Work Order ID 101159

Item Name: Crosstube Turning Detail

DART AEROSPACE LTD		Work Order:	101159
Description: Crosstube Assembly (205/212/412 High Fwd)		Part Number:	D212-664-141
Inspection Dwg: D212-664-141 Rev: D		Page 1 of 2

DRAWING NO. D212-664-141	TITLE XTUBE ASSY (205/212/412 HI FWD)	REV. D	DART AEROSPACE LTD ENGINEERING ORDER		D.E.O. NO. D212-664-141-D-1	SHEET NO. SHEET 1 OF 2	SCALE NTS
DRAWN	CHECKED	MFG. APPR.	APPROVED	DE APPR.			
DATE 11.04.07	DATE 11.04.11	DATE 11.04.12	DATE 11/04/12	DATE 11.04.12

D212-664-141/-141B
ASSEMBLY DETAIL

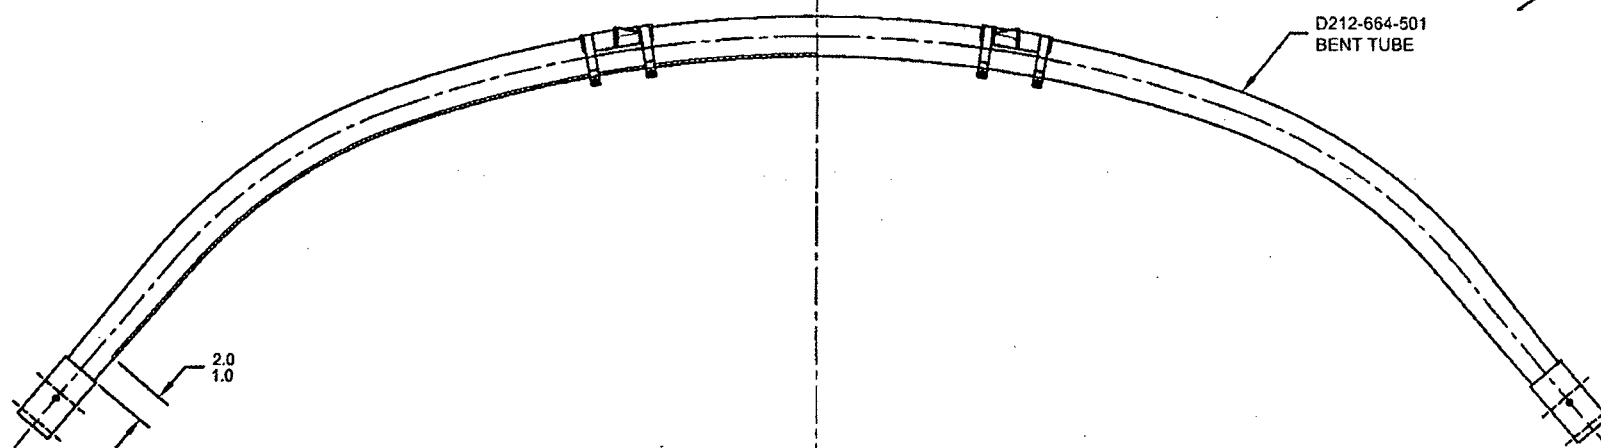
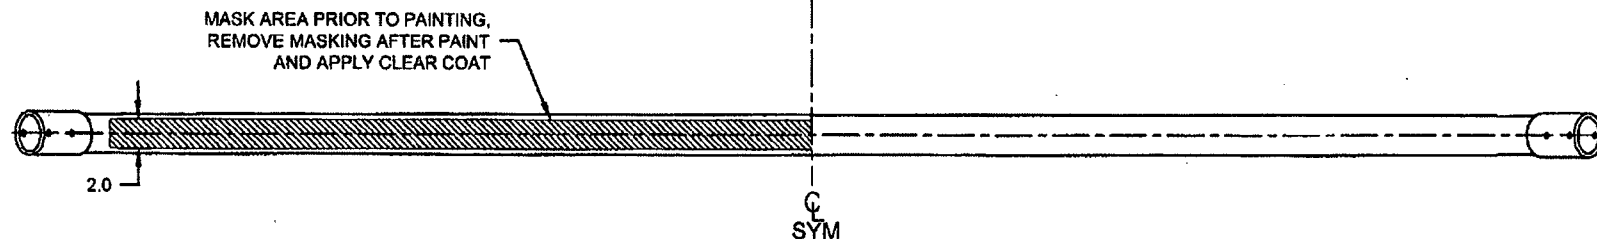
PURPOSE:

ADD AN INSPECTION WINDOW TO UNDERSIDE OF CROSSTUBE.

NOTES 2 OF SHEET 1 IS AMENDED AS FOLLOWS:

- 2) FINISH: CHEMICAL CONVERSION COAT PER DART QSI 005 4.1
PRIME INSIDE AND OUTSIDE PER DART QSI 005 4.2
MASK UNDERSIDE OF CROSSTUBE AS SHOWN (HATCHED AREA) AND
PAINT OUTSIDE PER DART QSI 005 4.2
REMOVE MASKING AND APPLY CLEAR COAT

- 2) FINISH: CHEMICAL CONVERSION COAT PER DART QSI 005 4.1
PRIME INSIDE AND OUTSIDE PER DART QSI 005 4.2
PAINT OUTSIDE PER DART QSI 005 4.2
